**ALERT SERVICE BULLETIN**

SUBJECT: REVISION "A" TO ALERT SERVICE BULLETIN 407-99-27, V<sub>NE</sub>  
RESTORATION TO 130 KIAS, INTRODUCTION OF.

**NO.** 407-99-27

**SUBJECT:**  $V_{NE}$  RESTORATION TO 130 KIAS, INTRODUCTION OF.

**Figure 1. New Airspeed Limitation Decal and Airspeed Indicator Glass Markings**

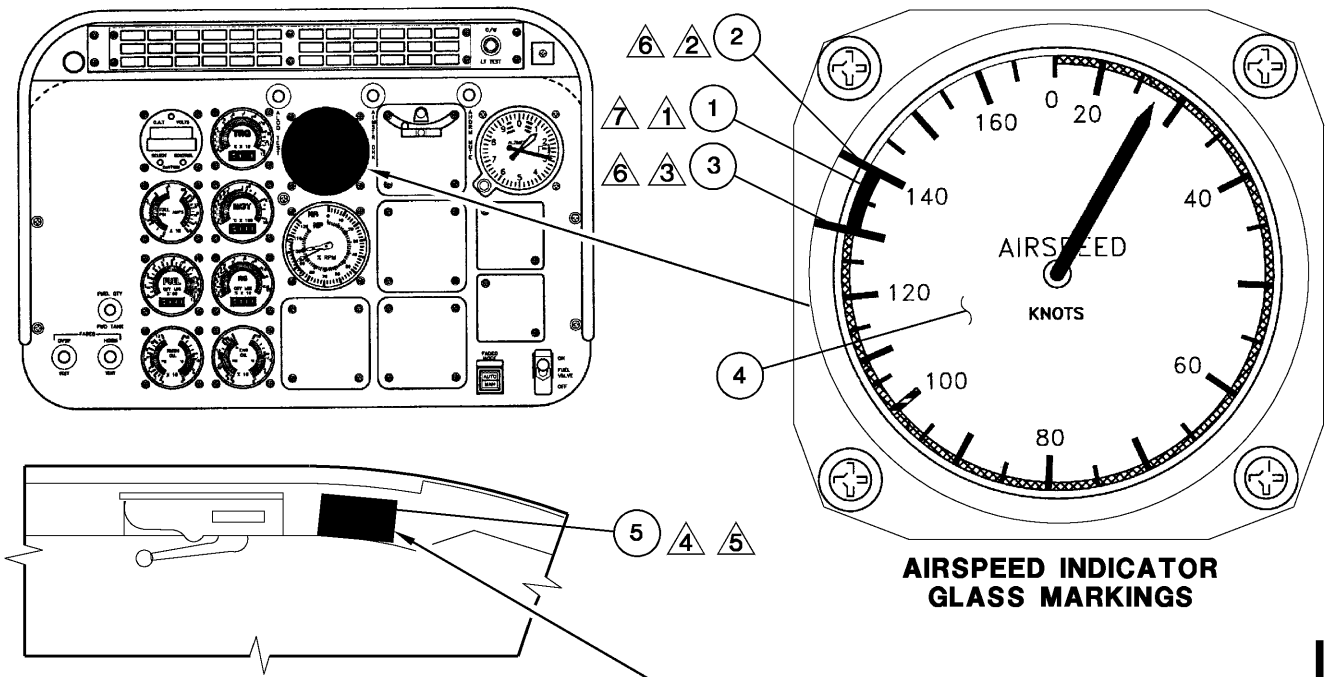
Revision "A" to this Alert Service Bulletin introduces a new Airspeed Limitation decal 407-070-201-121. This decal removes the 5 KIAS cutback above 20°C OAT. In addition the changes that follow are introduced by this bulletin.

1. Change the decal, Airspeed Limitations (5, Figure 1) as follows:
  - a. Remove the airspeed limitation decal found on the overhead trim panel near the windshield.
  - b. Lift one corner of the decal with a sharp knife and remove it.
  - c. Remove the decal adhesive that stays with aliphatic naphtha (C-305).
  - d. In the location of the removed decal, install the new adhesive-backed decal.
  - e. Apply edge sealer (C-349) to the edges of the decal.

2. Install temporary markings on the airspeed indicator glass face (4) as shown on Figure 1.

- 1 Apply decal on the cover glass to cover green arc.
- 2 Apply decal on the cover glass to cover the red V<sub>NE</sub> mark at 140 Knots.
- 3 Apply decal on the cover glass to cover the V<sub>NE</sub> mark at 130 Knots.
- 4 Apply edge sealer (C-349) to edges of the decal.
- 5 If you have the dual controls installed, one more decal is installed on the co-pilot side.
- 6 Decals (2, 3) to exceed glass periphery as shown to prevent rotation of the cover glass.
- 7 Trim decal (1) to fit.
- A. | 8 If you have the quiet cruise mode kit 407-706-016 installed, decal 407-070-201-123 instead of 407-070-201-121 is needed. Refer to BHT-407-FMS-25, Section 1, Limitations.
